knitter-switch

Product Change Notice P04-2025

Products affected: DPW/DPWL series, details see page 2

Effectivity date: 30.11.2025

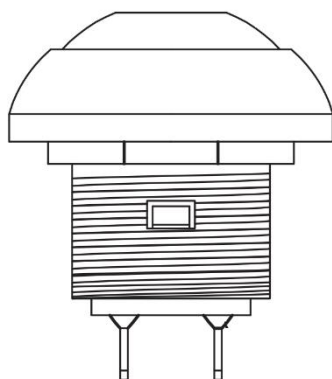
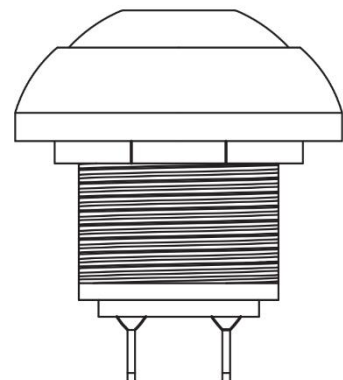
In course of continuously product improvement the manufacturing process of the switching element inside the bushing has been optimized.

The bushing design has been modified to eliminate the cutout for the fixing pin
